AGENDA

President and Board of Trustees
Village of Arlington Heights
Board Room

November 20, 2017

File Number: PC# 17-010
Project Title: St. Edna's Catholic Church
Address: 2525 N. Arlington Heights Rd.
PIN: 03-17-101-019

NO.	DESCRIPTION	DATE
	FIRE ALARM PLAN	
	DRWN: AT, BC, KM	PLOT DATE: 05/01/2017
	CHECKED: SIT	
	JOB NUMBER: M16025	
		E3.1

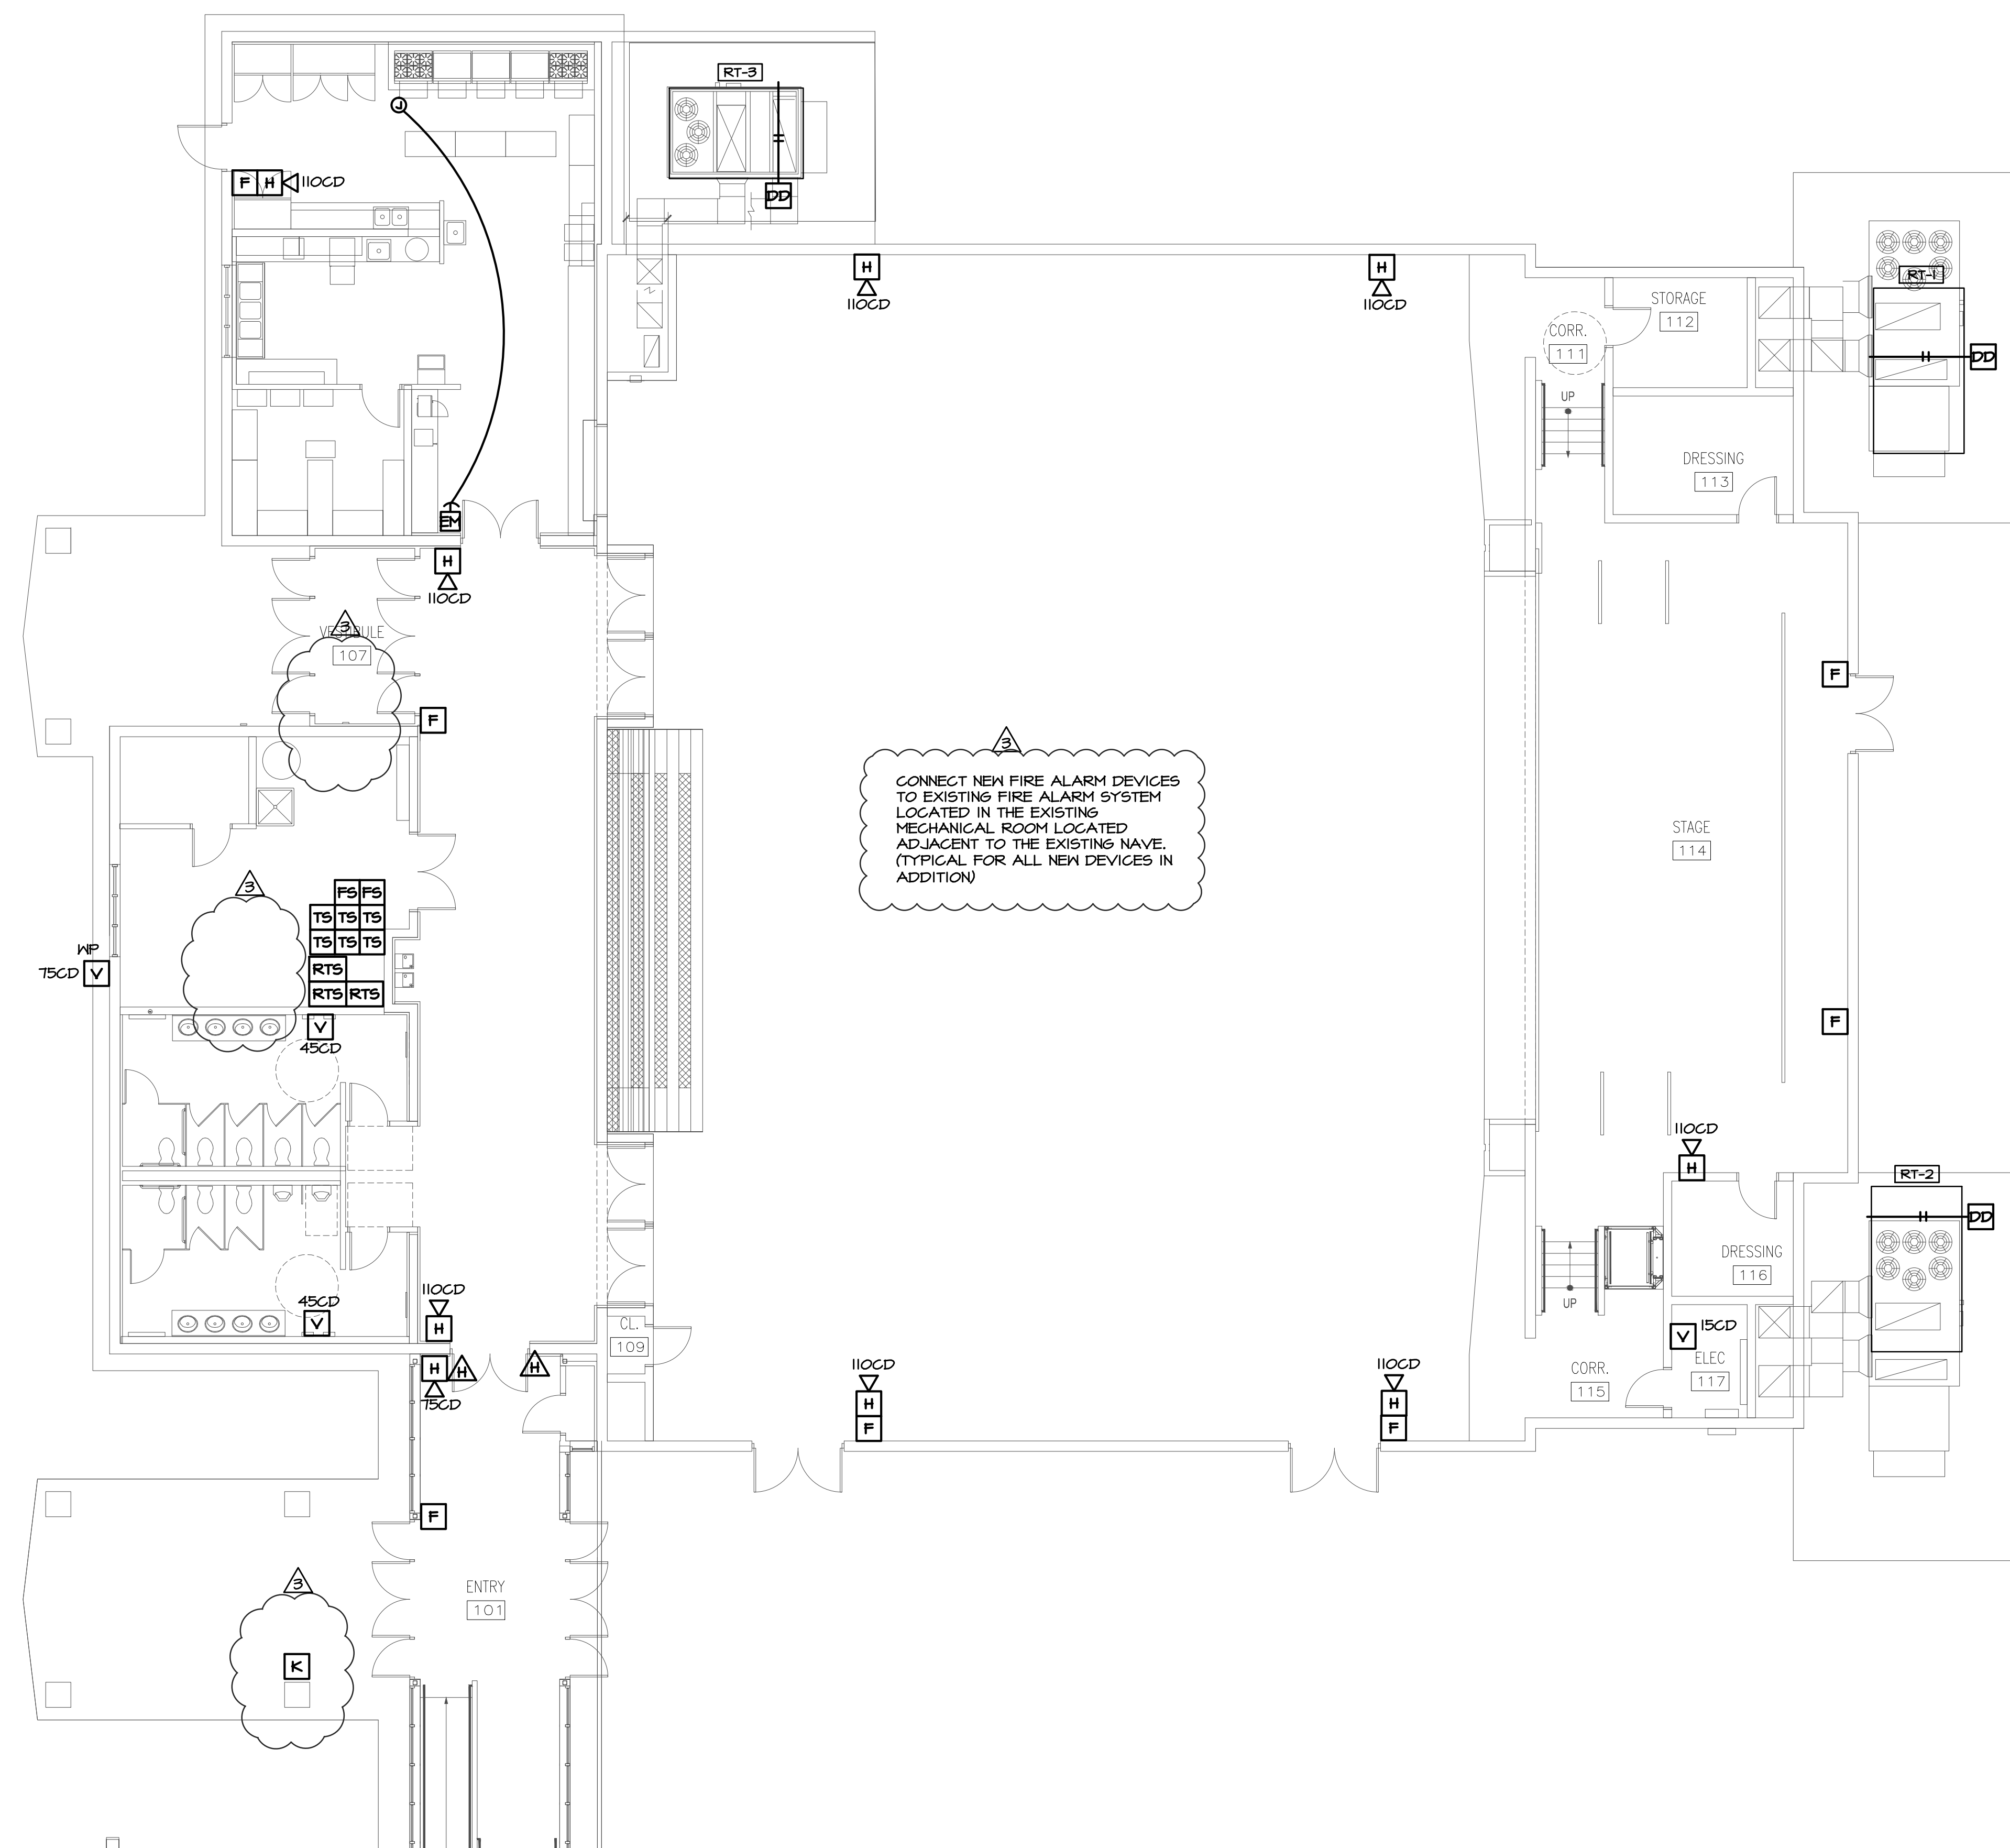
5. A complete fire alarm system is required and will be required to be connected to the existing structure.
A complete fire alarm system will be provided and will be connected to the existing fire alarm system. See revised sheets E3.1 and E4.1

4. A complete alarm system that will be connected with the existing structure with a fully functioning annunciator panel at the main entrance.
An addressable system was installed in the existing building in 2002. A complete fire alarm system has been provided in the new building and will be connected to the aforementioned existing fire alarm system. See revised sheet E3.1 and E4.1

FIRE PROTECTION PLAN

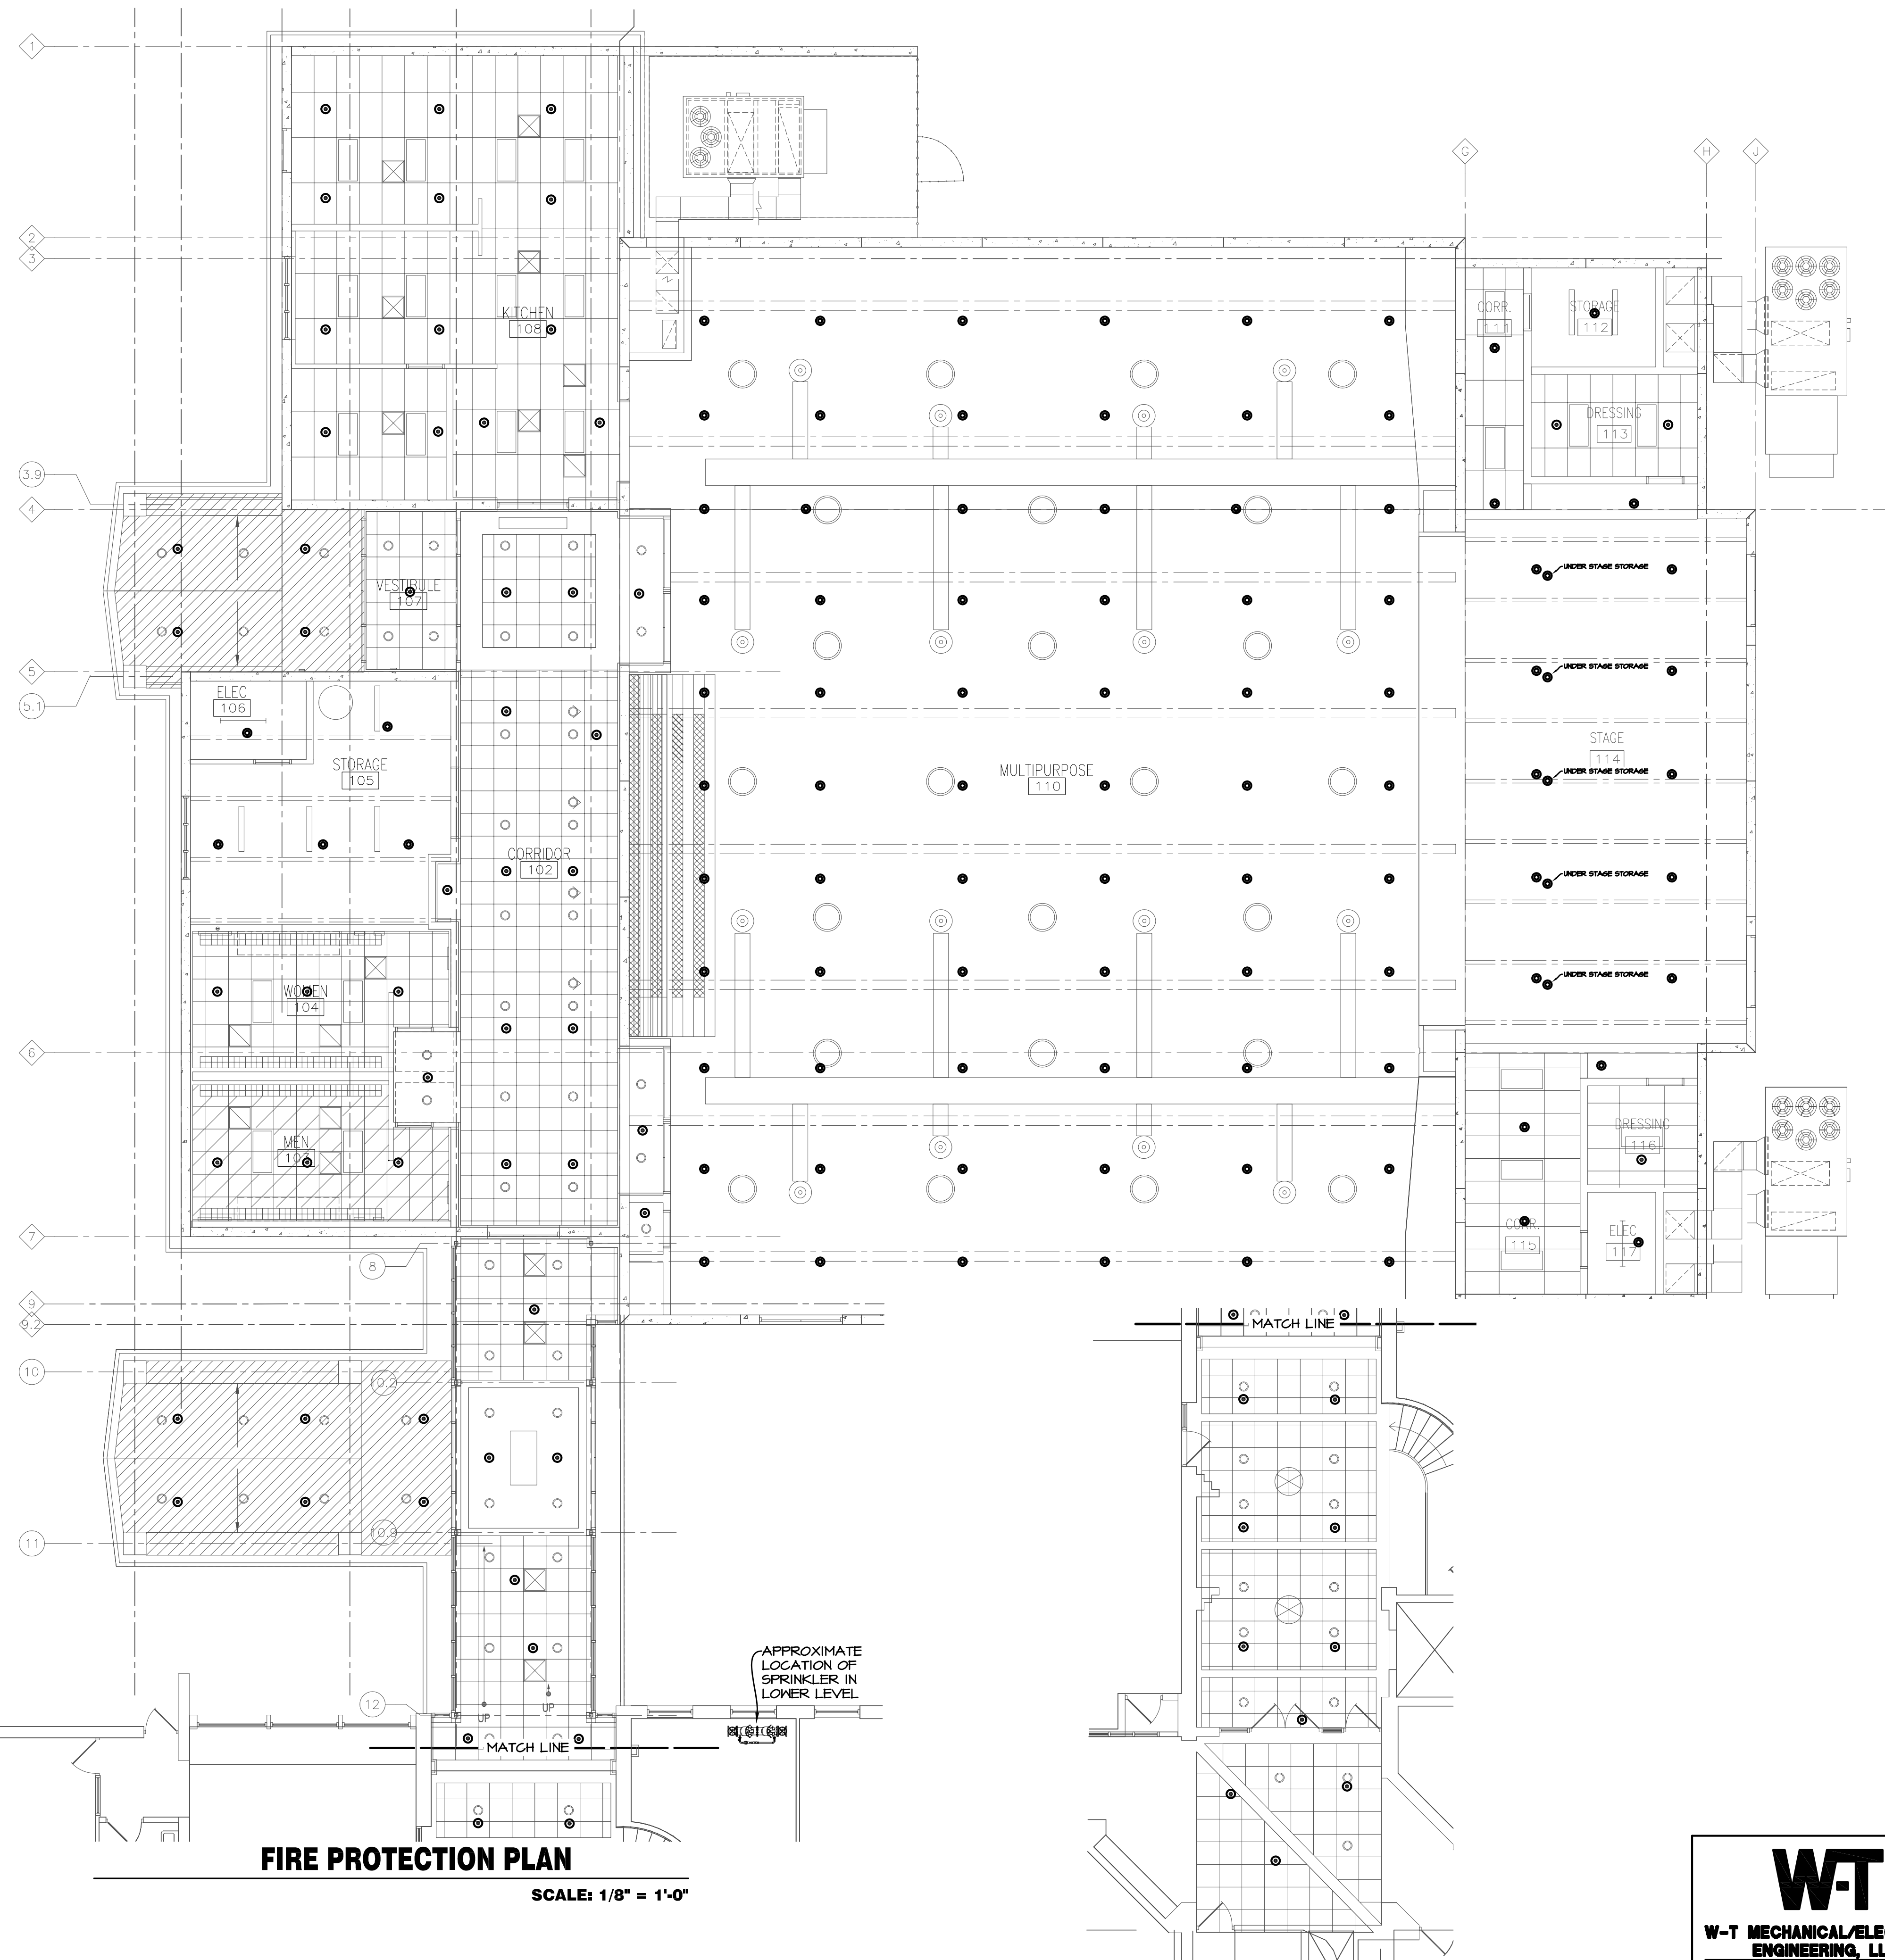
1. Could we please get an auto turn diagram for fire apparatus.
An auto turn diagram for a fire apparatus has been provided. See sheet FT-1
2. Building to be sprinkled.
The proposed building will be sprinkled. See attached sheet FP1-1 for the sprinkler layout. Shop drawings will be provided for review prior to fabrication or installation of the system.
